GPIB ASIC Reference Manual

Errata

The changes described in this document are important information for users of the *NAT7210 Reference Manual*, the *NAT9914 Reference Manual*, and the *TNT4882 Programmer Reference Manual*.

Figure 1. New Figure C-7 for Page C-22

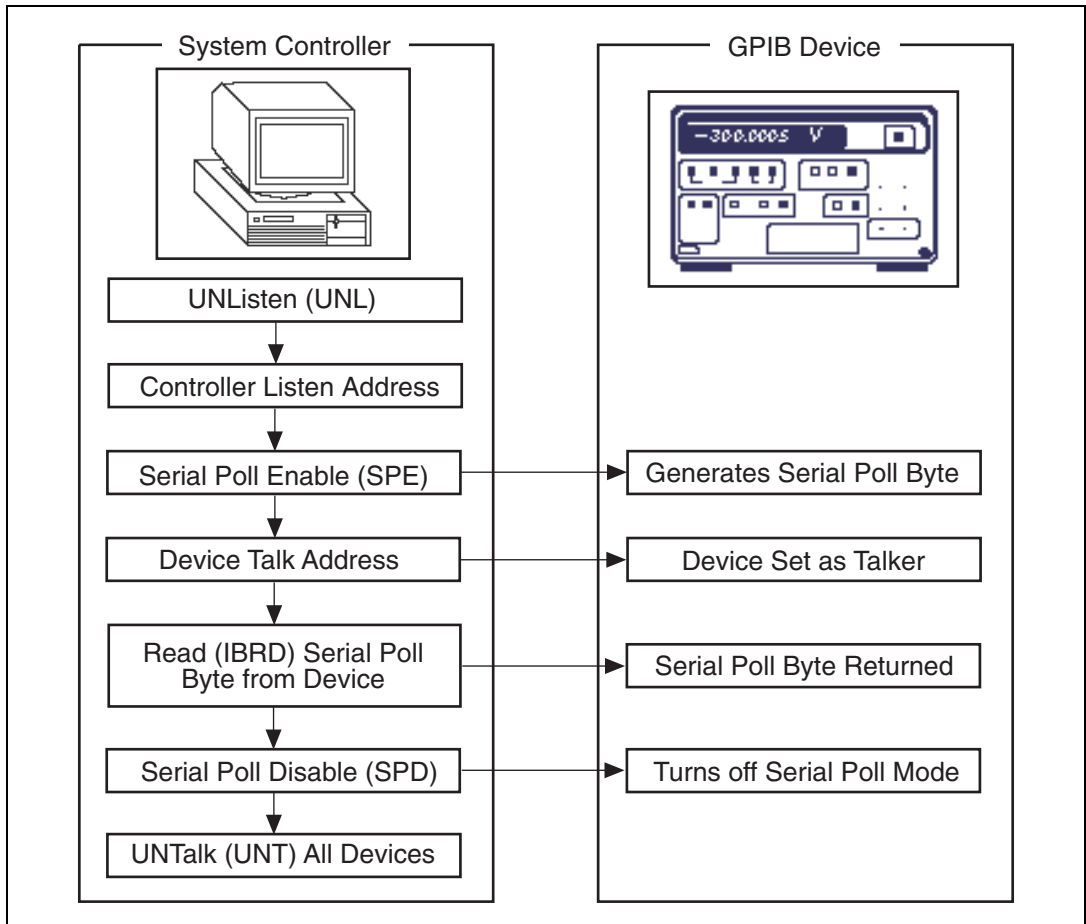
- Page C-22, replace the existing Figure C-7 with the following figure,
